PNP 2011-016

March 7, 2011

SUBJECT: License Amendment Request for Primary Coolant System
Pressure-Temperature Limits

Palisades Nuclear Plant
Docket 50-255
License No. DPR-20

Figure 3.4.3-1 (Page 1 of 1)
Pressure – Temperature Limits for Heatups
Applicable up to 42.1 EFPY

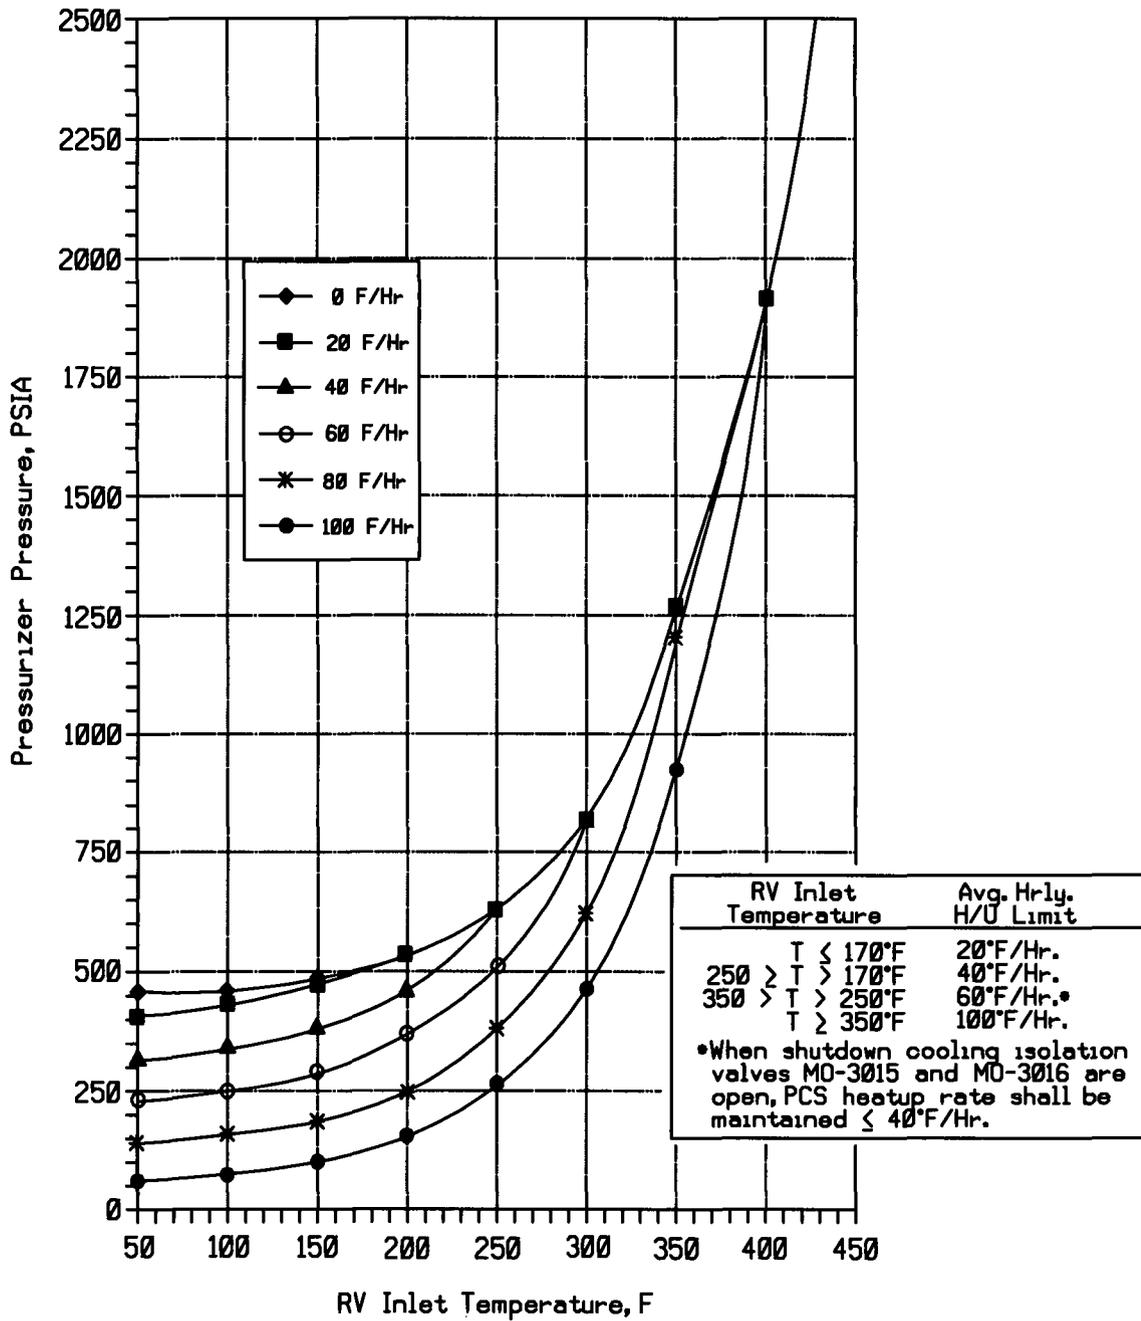
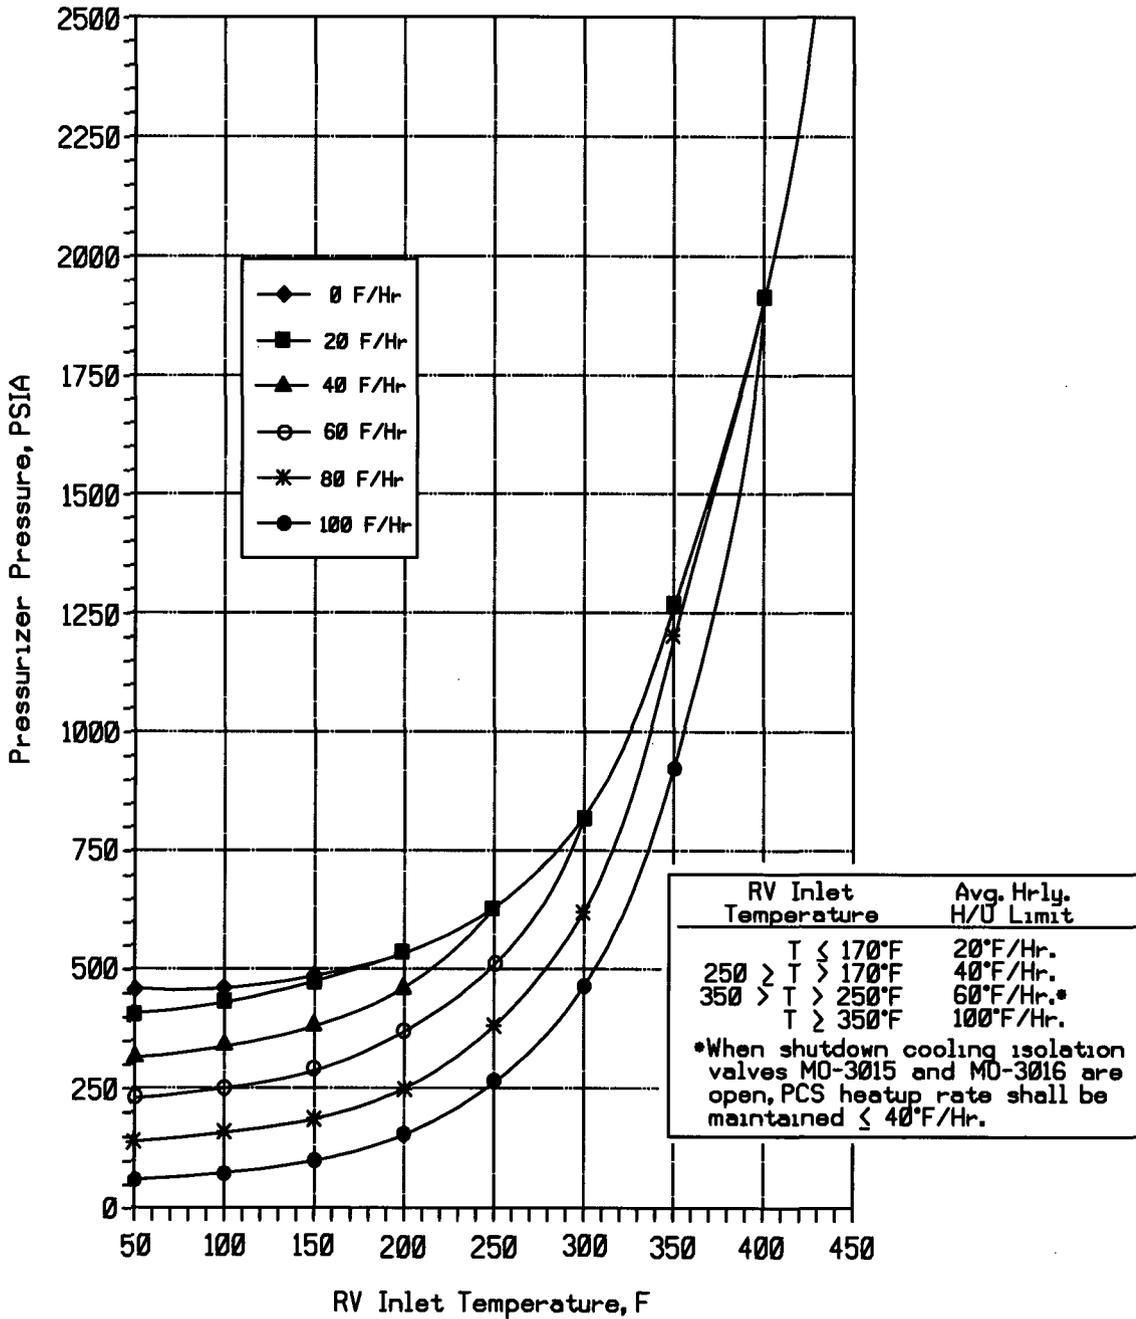
The proposed change revises the figures referenced in LCO 3.4.3 and LCO 3.4.12 by adding the applicability period of 42.1 EFPY to Figure 3.4.3-1, “Pressure – Temperature Limits for Heatups,” Figure 3.4.3-2, “Pressure – Temperature Limits for Cooldown,” and Figure 3.4.12-1, “LTOP Setpoint Limit.”

Figure 3.4.3-1 (Page 1 of 1)
Pressure – Temperature Limits for Heatups
Applicable up to 42.1 EFPY

Figure 3.4.12-1 (Page 1 of 1)
LTOP Setpoint Limit
Applicable up to 42.1 EFPY

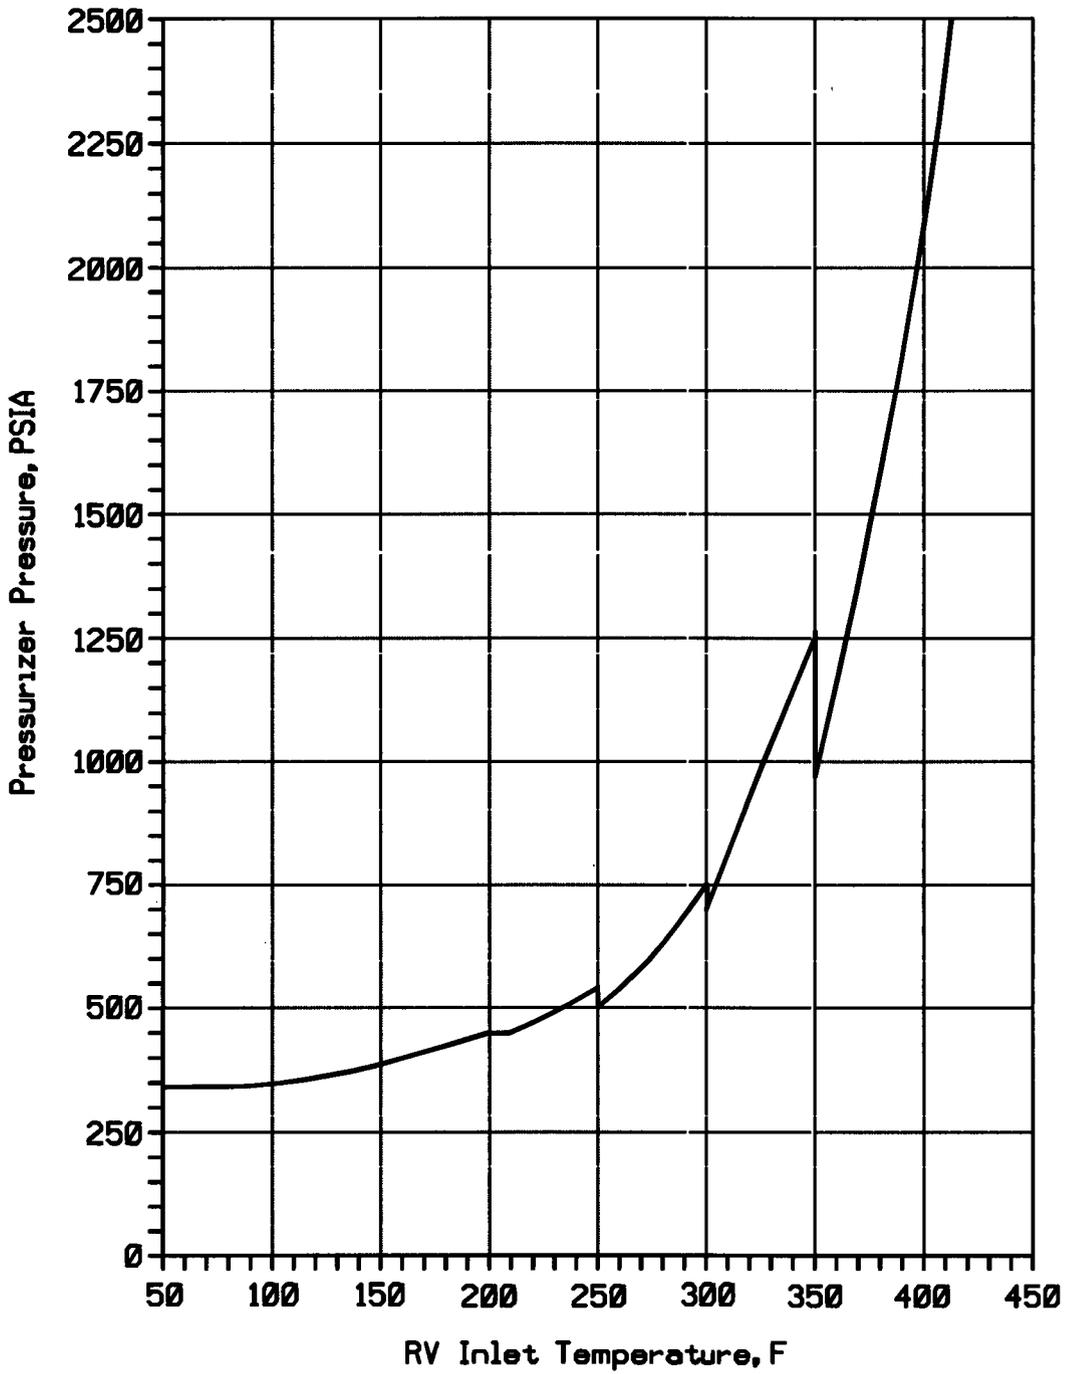
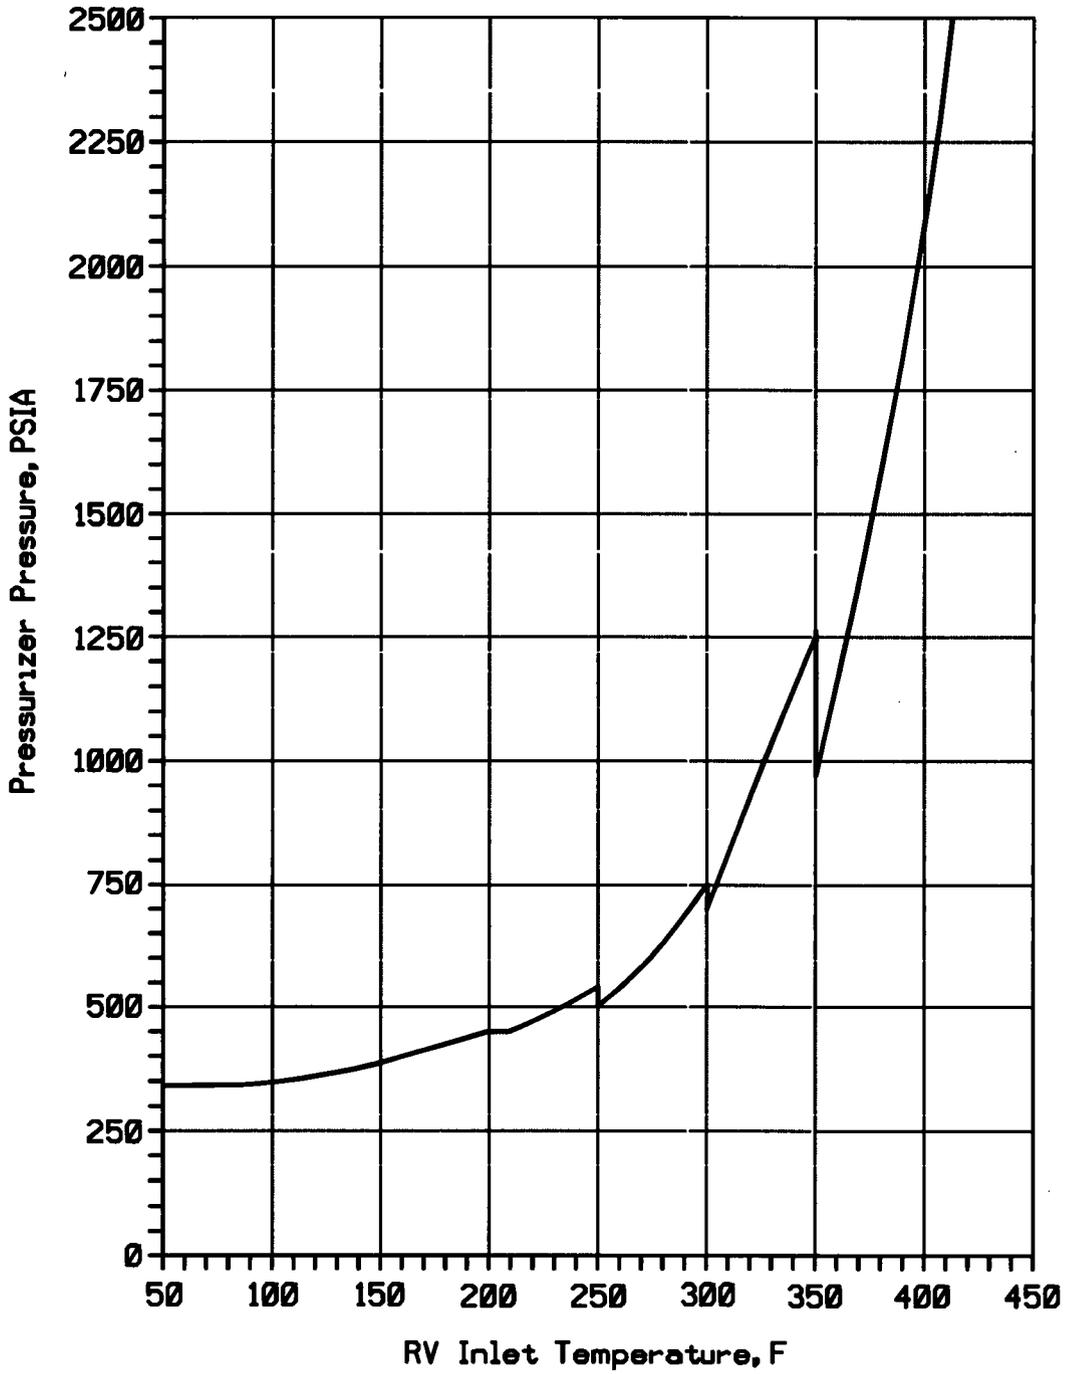
The 42.1 EFPY applicability period is also added to LCO 3.4.12 Figure 3.4.12-1, "LTOP Setpoint Limit."

Figure 3.4.12-1 (Page 1 of 1)
LTOP Setpoint Limit
Applicable up to 42.1 EFPY
